ABOUT ADSP-BF561 SILICON ANOMALIES

These anomalies represent the currently known differences between revisions of the Blackfin® ADSP-BF561 product(s) and the functionality specified in the ADSP-BF561 data sheet(s) and the Hardware Reference book(s).

NR002863U

107. 05000471 - Boot Failure When SDRAM Control Signals Toggle Coming Out Of Reset:**DESCRIPTION:**

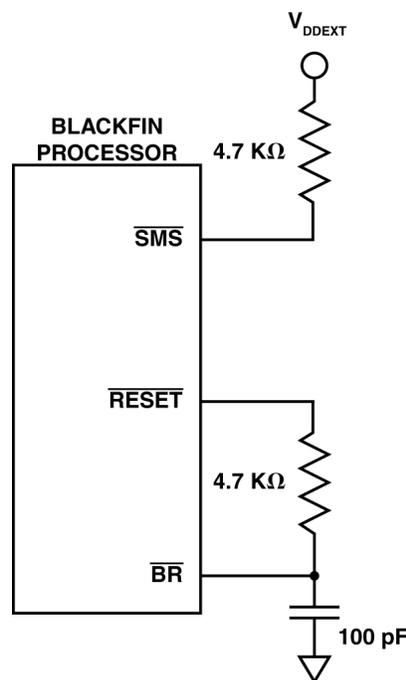
When $\overline{\text{RESET}}$ is de-asserted at the conclusion of the power-on reset sequence (not applicable to warm resets), there is a very small chance that the SDRAM control signals ($\overline{\text{SRAS}}$, $\overline{\text{SCAS}}$, $\overline{\text{SWE}}$, $\overline{\text{SMS}}$, $\overline{\text{SCKE}}$, and SA10) may be driven low for a single CLKOUT cycle. This activity can cause certain SDRAM devices to enter engineering test modes that result in the SDRAM driving data onto the shared EBIU data lines that the Blackfin processor is going to read from when configured to boot or execute from parallel flash.

When booting from parallel flash (BMODE = b#01), this contention corrupts the boot stream and causes the processor to hang. At this point, power-cycling the processor is required to clear the condition.

When executing from parallel flash (BMODE = b#00), this contention corrupts the op-codes and causes the processor to execute incorrect or illegal instructions, which may result in improper application execution or unexpected exceptions.

The delayed version of $\overline{\text{RESET}}$ seen on $\overline{\text{BR}}$ causes the Blackfin processor to continue to three-state the SDRAM control signals after the rising edge of $\overline{\text{RESET}}$ for longer than one CLKOUT cycle, which over-rides the glitch behavior described by this anomaly. The pull-up resistor on the $\overline{\text{SMS}}$ pin ensures that the memory-select signal remains de-asserted while the processor is three-stating the $\overline{\text{SMS}}$ output. Additional pull-ups are needed on the $\overline{\text{AMSx}}$ signals as well. This drawing contains the local connections to the Blackfin processor only. The $\overline{\text{RESET}}$ input pin is connected to the reset supervisor circuit, and the $\overline{\text{SMS}}$ output pin connects to the SDRAM memory select pin.
